**Northeast Oregon Hatchery Program  
Grande Ronde - Imnaha Spring Chinook Hatchery Project  
Supplement to Biological Assessment**

**March 2006**

This document represents a supplemental analysis to the BA previously submitted to the USFWS and NOAA Fisheries (Services) to update project reviewers on design changes and anticipated impacts those changes may have on listed species. In addition, this document considers updates to the critical habitat listings for Columbia River bull trout (*Salvelinus confluentus*) and for Snake River steelhead (*Oncorhynchus mykiss*) and recommends effect determinations for those designated habitats. The project has previously undergone formal ESA consultation (effect determination for all listed anadromous species was Likely to Adversely Affect); proposed project changes do not affect this determination and are not anticipated to result in impacts that exceed the level of take previously authorized in the BOs prepared for this project.

Figure 2. Current Lostine River Hatchery Site Plan.

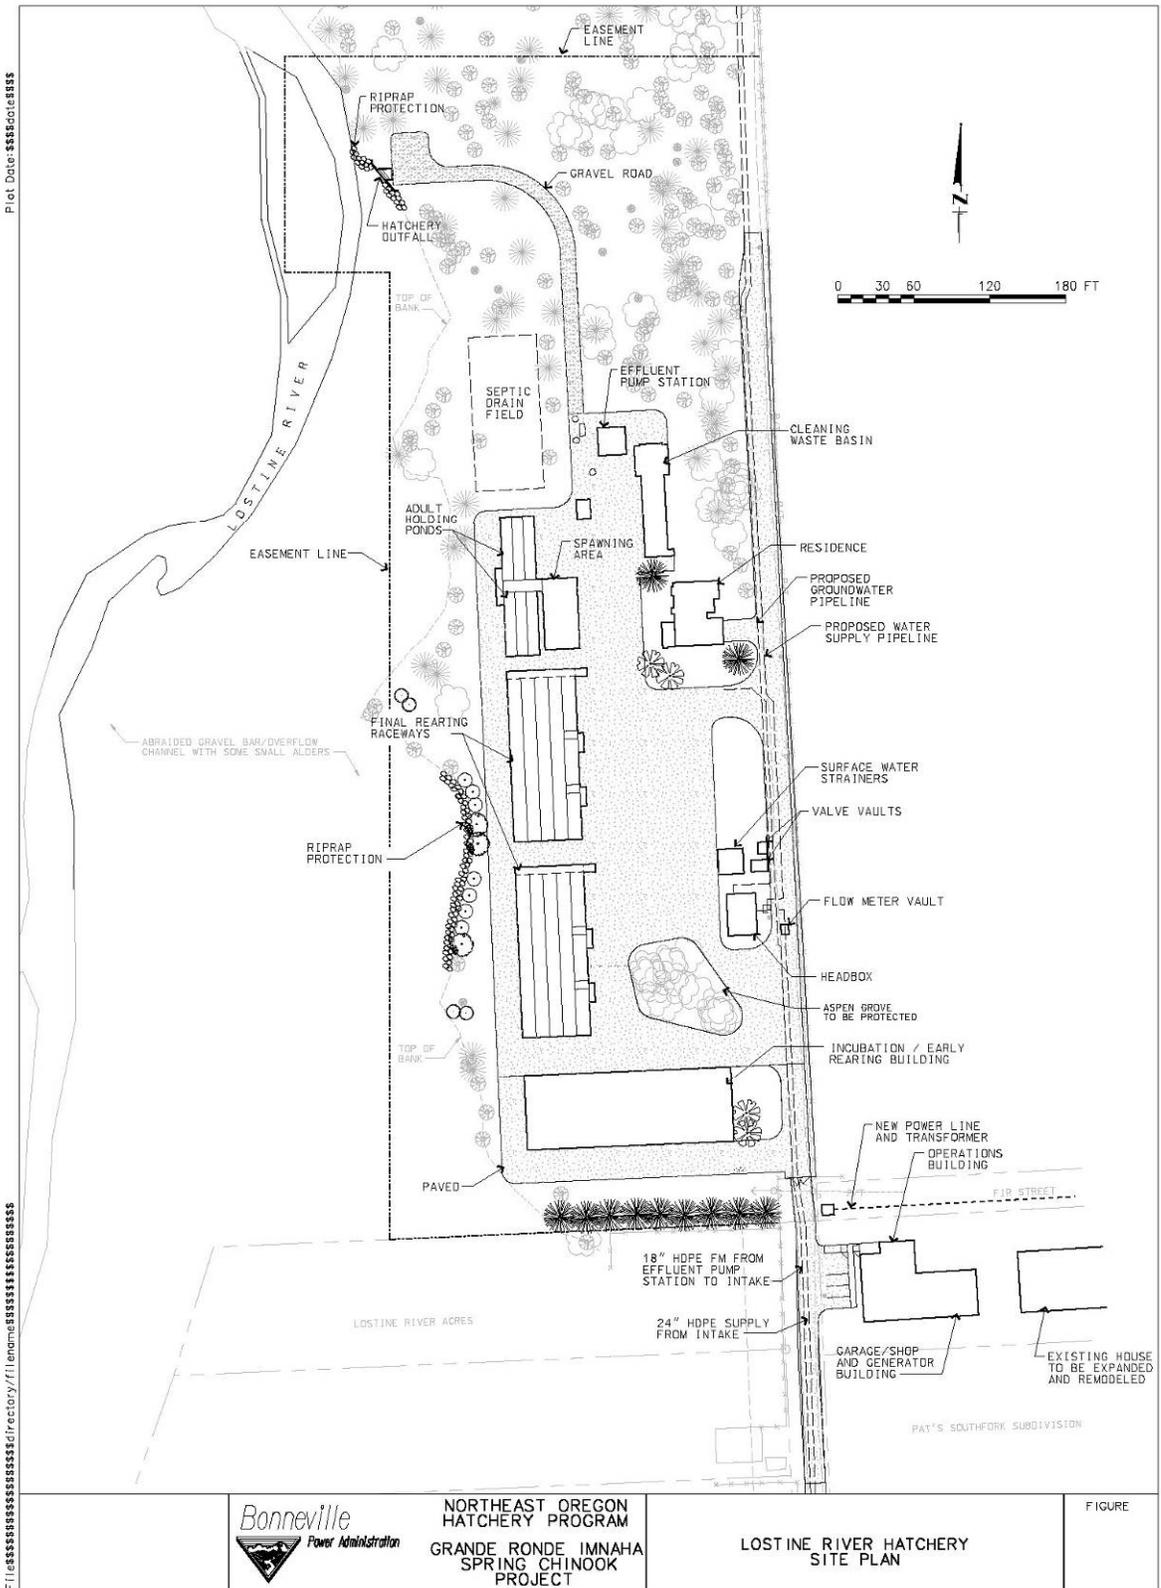
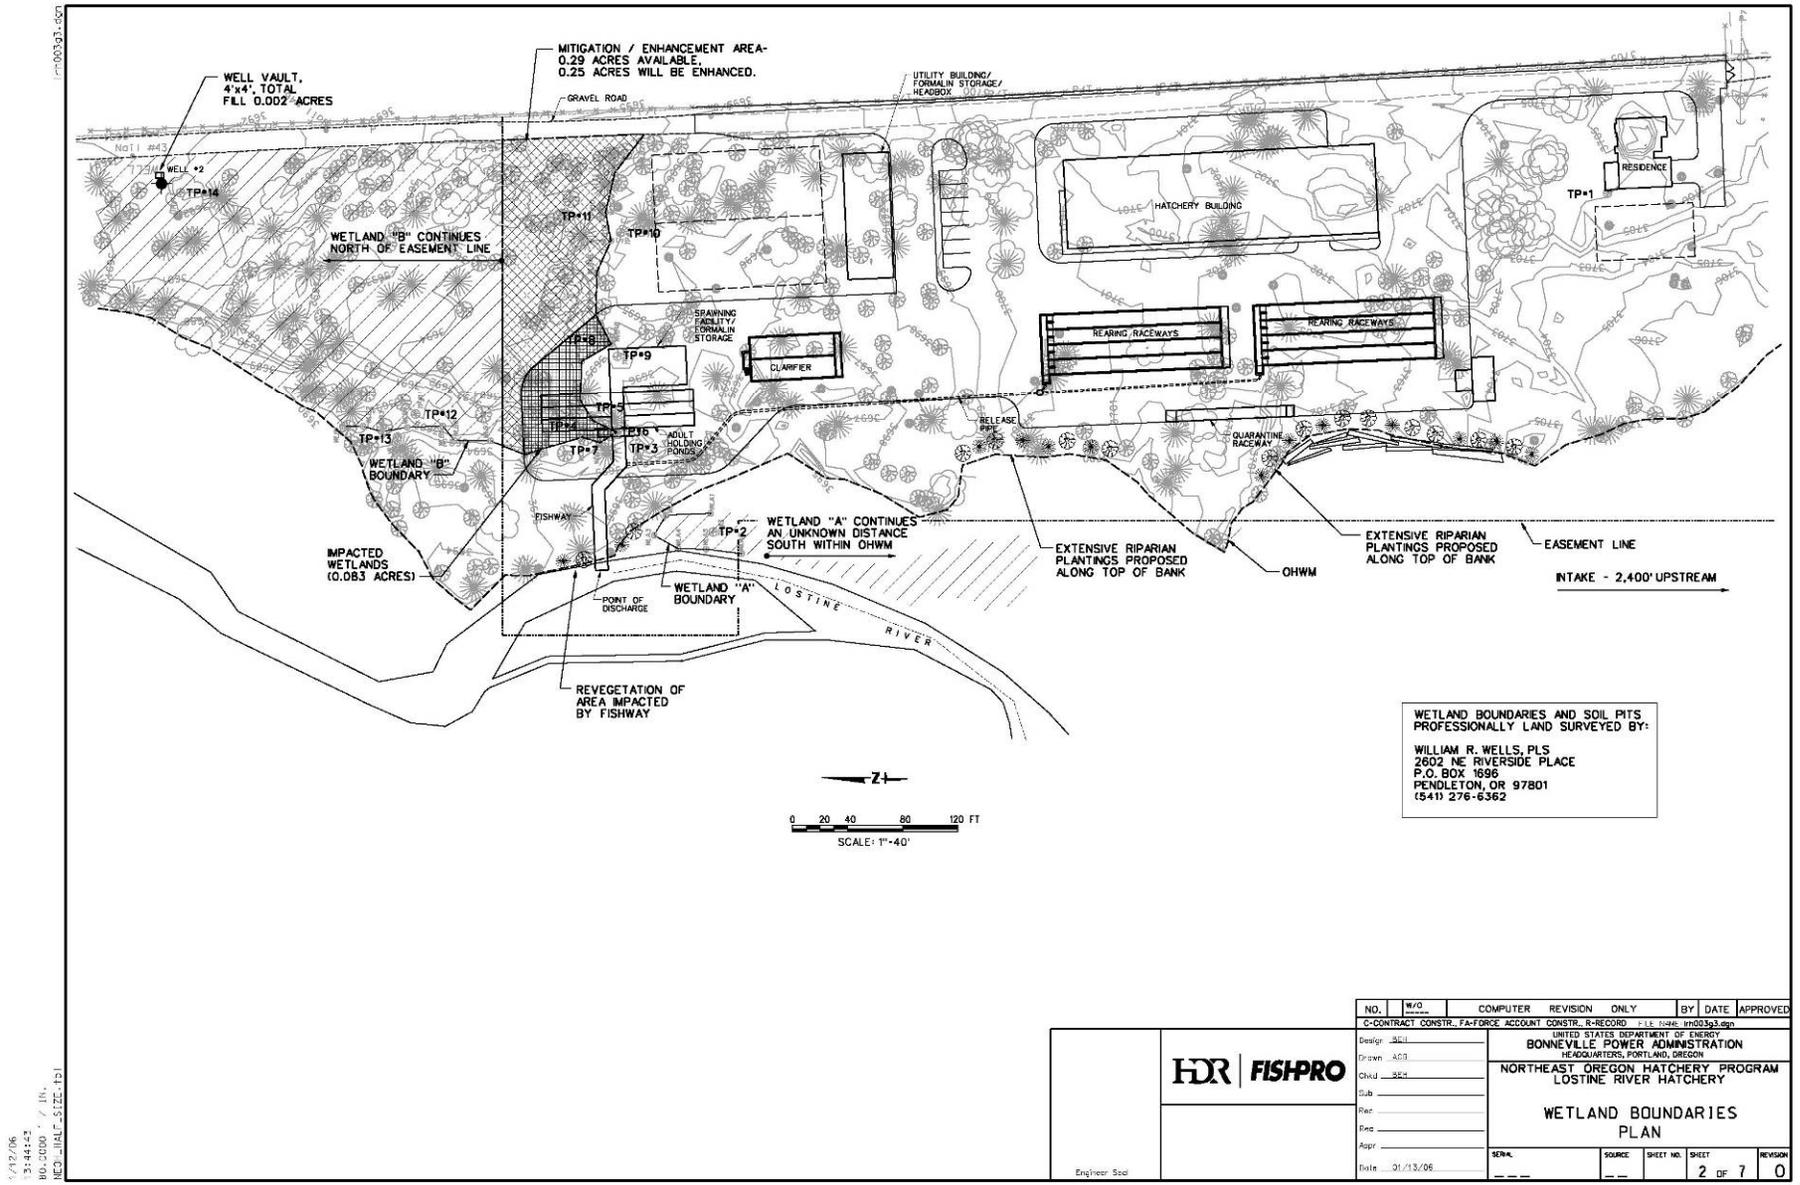
In general, the new site plan (Figure 2) contains similar components to those presented on the original site plan; however, several structures have been shifted to the north or relocated throughout the hatchery easement. Although the basic construction area remains the same, the amount of new impervious surface has been increased from 1.9 acres in the original proposal, and is now approximately 2.8 acres.

The new design has several components located in an area that was previously planned to include only an access road to the outfall structure. The outfall structure is now proposed to be replaced with a fishway/outfall. Associated structures including a spawning building and adult holding ponds will be located on the northern end of the parcel. The spawning building is sited on the northern portion of the parcel to allow gravity flow through the hatchery and minimal fishway length.

The bank stabilization technique along the western portion of the facility has been modified. Instead of using riprap, large trees will be anchored to the slope and native shrubs will be planted to reinforce the bank (see Figure 2, slope protection area lined with downed trees). This bioengineering activity will occur above the Ordinary High Water Mark (OHWM) during the summer to prevent potential sedimentation into the meander channels at the toe of the slope. These channels are generally dry during the summer, so no impact to aquatic species is anticipated from this activity.

Figure 3. Intake Access Road and Surface Water Pipeline Corridor.

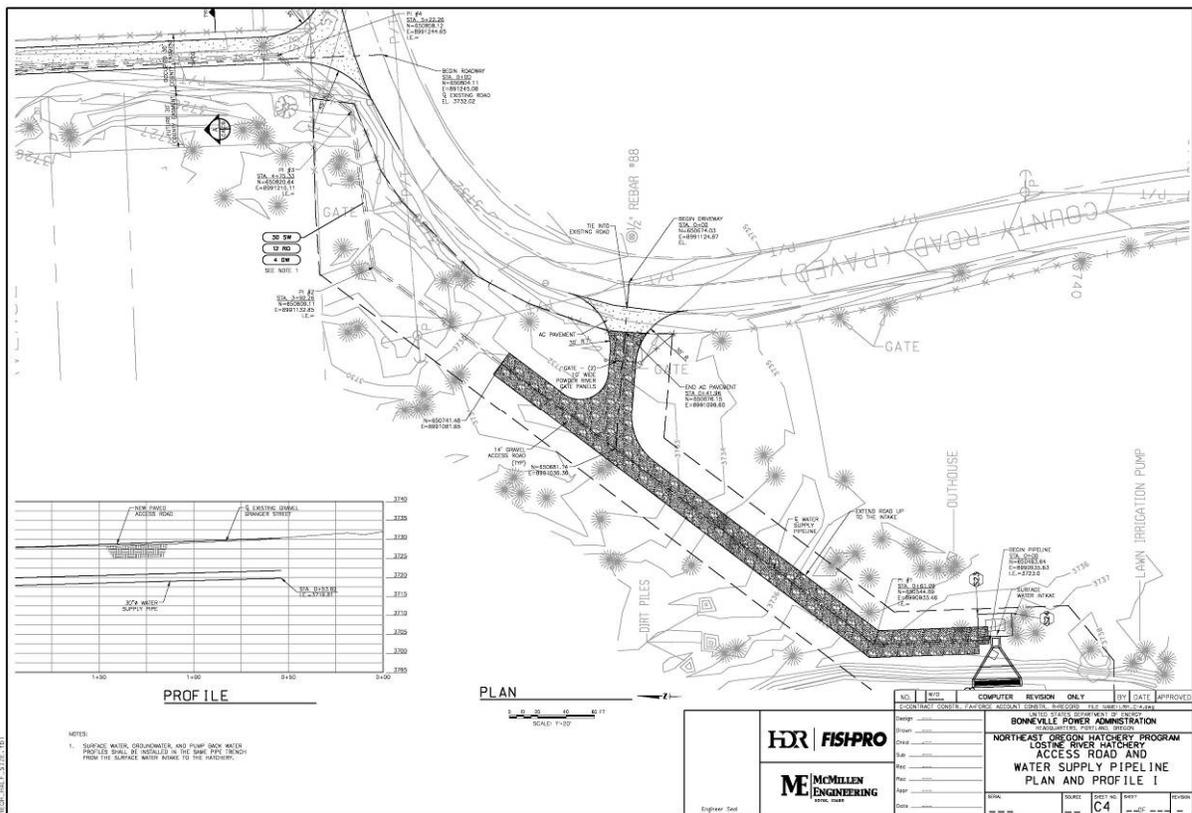
Due to the relocation of the intake structure (described in the next section - *Streambank and Instream Component Changes*), the associated intake access road and pipeline corridor have also been relocated (Figure 3). The newly designed access road (12 ft wide) will require the removal of approximately 0.05 acres of upland vegetation, primarily herbaceous grasses within a privately owned easement (leased to BPA for the development and use of the intake and associated infrastructure; see photo of area in Appendix A). The access road will be routed around mature trees to avoid their removal. The buried 24-inch diameter gravity pipeline that will convey surface water from the intake to the hatchery site will traverse private property until the junction with Granger Road. The pipeline will be buried immediately adjacent to Granger Road on the western side of the road easement. Because the pipeline will no longer be buried beneath Granger Road (to avoid access impacts to local residents during formerly proposed road improvements), the road is no longer proposed for paving and will remain in its current condition and configuration. The BA stated that approximately 10 mature trees that currently line Granger Road were to be removed during installation of the pipeline and subsequent roadway improvements. Installation of the pipeline immediately west of the road should not result in additional tree removal.

Figure 5. Newly designed Lostine River Hatchery intake structure.

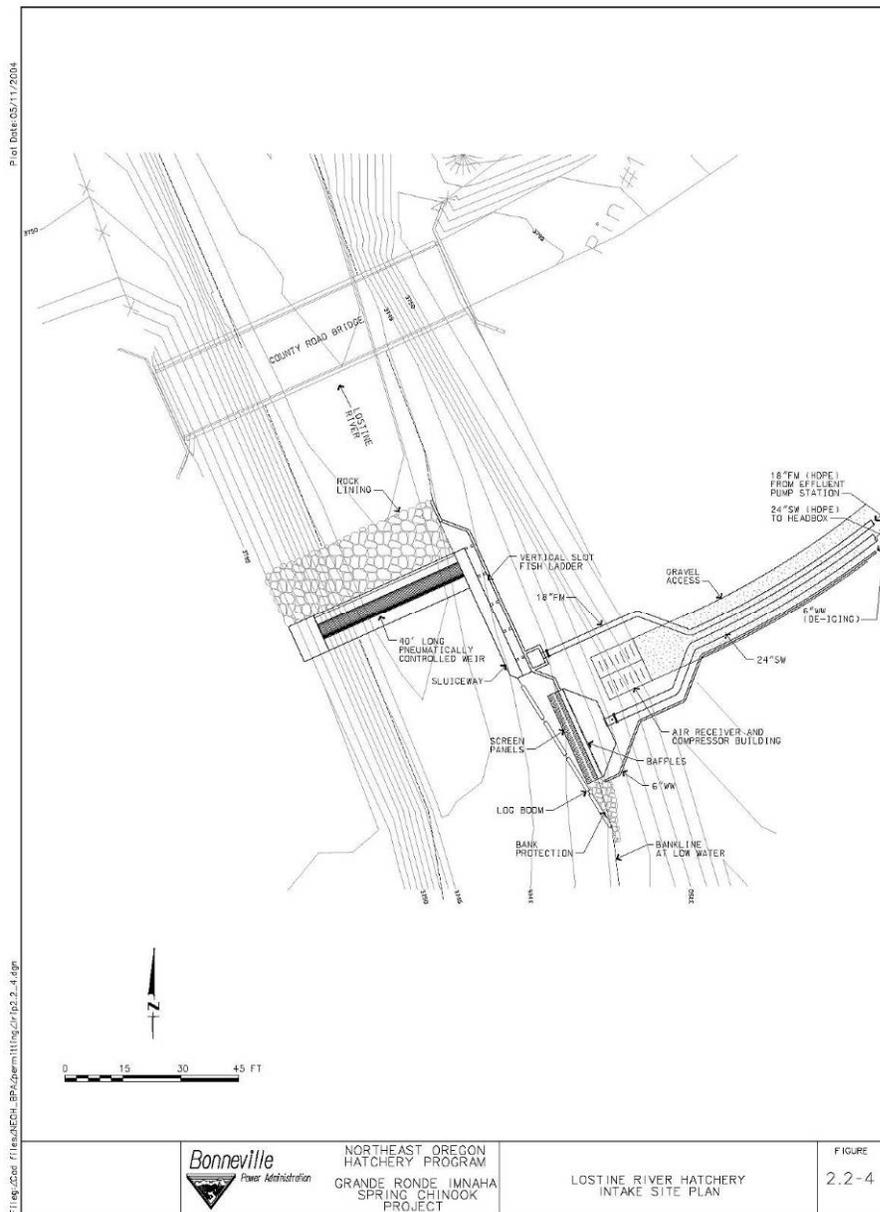
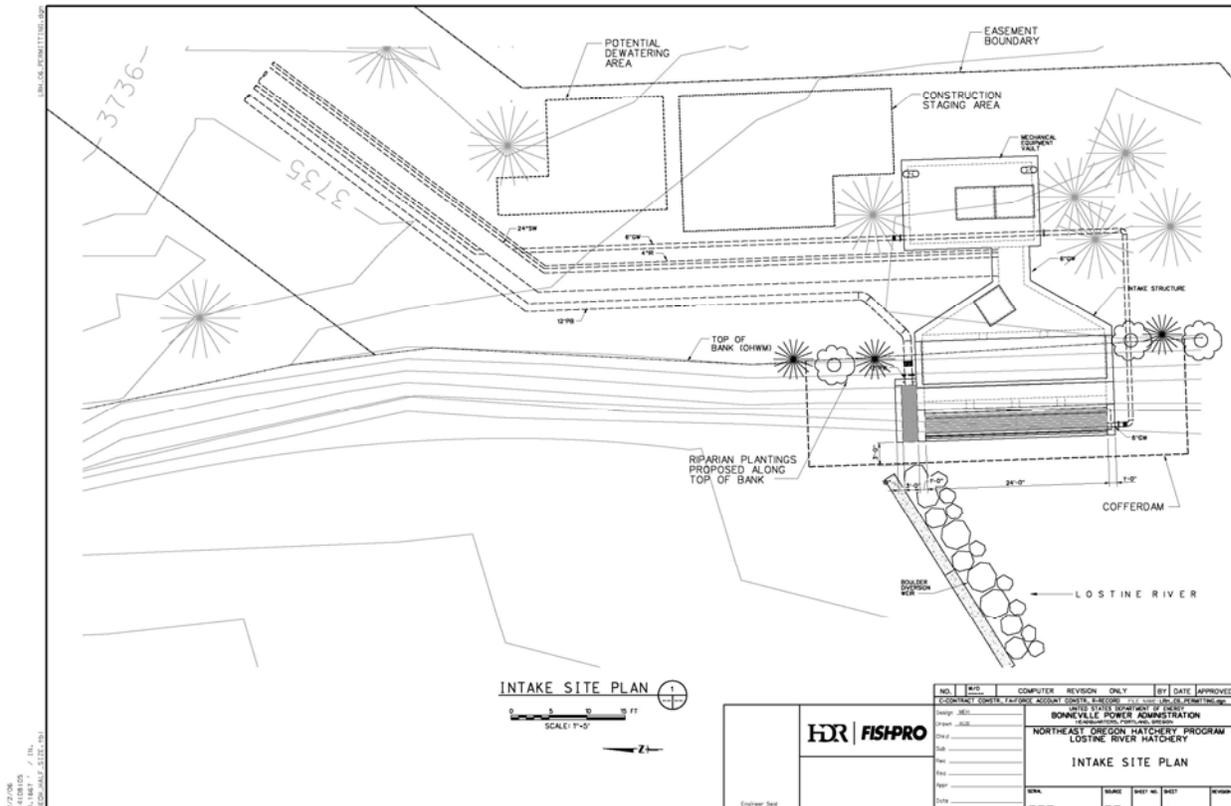
The surface water intake structure as originally proposed is shown in Figure 4. The intake was originally sited approximately ½ mile south of the hatchery parcel, just upstream of the County Bridge, and was designed to supply up to 17.8 cfs to the facility. The intake facility was to include a cast-in-place intake on the east bank of the river, a pneumatically-operated weir to control the water surface elevation, a fish ladder for passage, a sluiceway for periodic downstream sediment transport past the weir, a log boom to protect the screen panels and a compressor building to house the air receiver and compressor. An air system was proposed to provide air burst cleaning to the screen panels and to inflate the pneumatically-controlled weir.

Due to property acquisition issues and design constraints relating to construction, the location of the proposed intake has been moved approximately 400 feet downstream from the location identified in the BA. This relocation reduces the diversion reach affected by hatchery surface water withdrawals. Photos of the new intake location are included in Appendix A, photos A-1 and A-2. The river reach in the new location is more constricted than the previous location and the substrate is characterized by large cobbles and small boulders. The new intake structure has been redesigned (see Figure 5) to supply up to 18.0 cfs to the hatchery (surface water requirements are 16.7 cfs; however, redesign takes into account a buffer factor for an intake screen). Elements of the new intake are:

A buried concrete sill is proposed to span the river and serve as substrate onto which the rock weir will be positioned. This sill was recommended by NOAA Fisheries Engineer, John Johnson during an October 2005 site visit (pers comm., 10/05); conceptual designs for the intake structure were also approved by Mr. Johnson during the site visit. It should be noted that the verbal approval is conditioned upon review of final engineering plans. The rock weir will route water to the intake screens. During normal or high flow events, the river will top the rock weir, allowing fish passage. During low flows, a three-foot opening in the weir adjacent to the right bank will provide fish passage.

Figure 6. Proposed Lostine River Hatchery Fishway

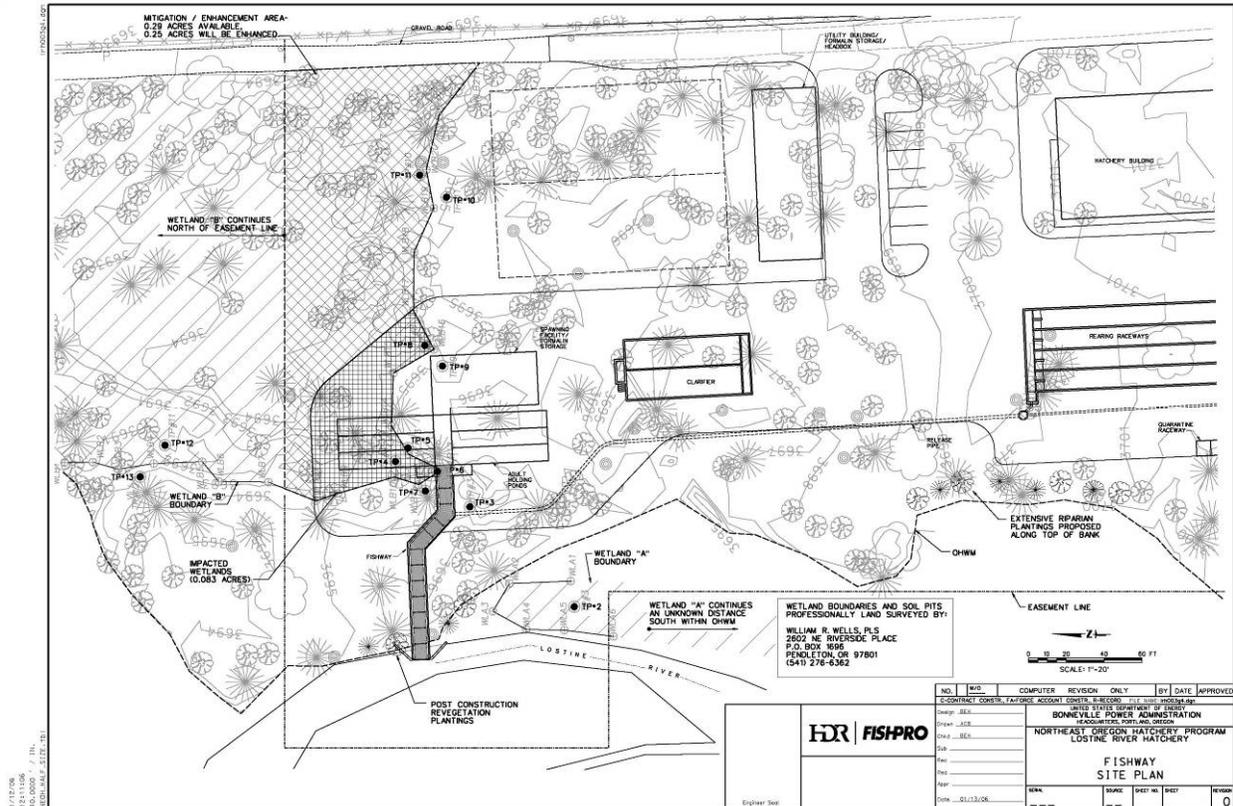
As discussed previously, to mitigate for loss of the high flow adult collection capability that the LACF was to provide, a fishway is now proposed in the vicinity of the original hatchery outfall location. This fishway will be combined with the outfall to limit impacts to the streambank during construction. The fishway will be a pool and step ladder (with one foot drops; Figure 6) approximately 102 feet long that will route fish that enter the ladder into a trapping/sorting area. During the initial years of operation, the trapping facility will be visually inspected daily; non-target fish will be held for no longer than 24 hours before being returned to the river. Trapping procedures are discussed in greater detail in the *Operational Changes* section later in this document.
